2009 Solar Program Peer Review, Overview of Results for CSP

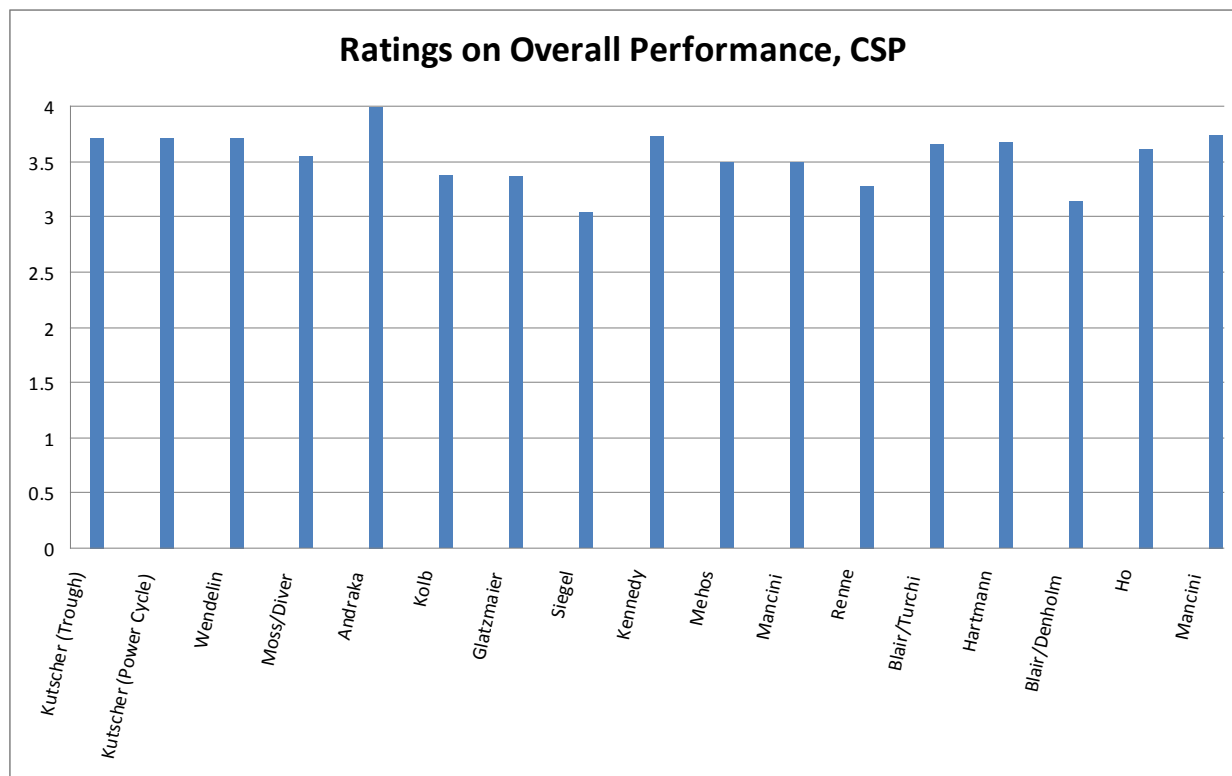
Figure 1 below shows the rating each project received from the peer reviewers in terms of their “Overall” performance. The ratings are an average of the scores given by the four peer reviewers in this panel. They provide a broad comparison between the projects.

All of the projects in the *Concentrating Solar Power* tracks fell into the 3.0 to 4.0 range.
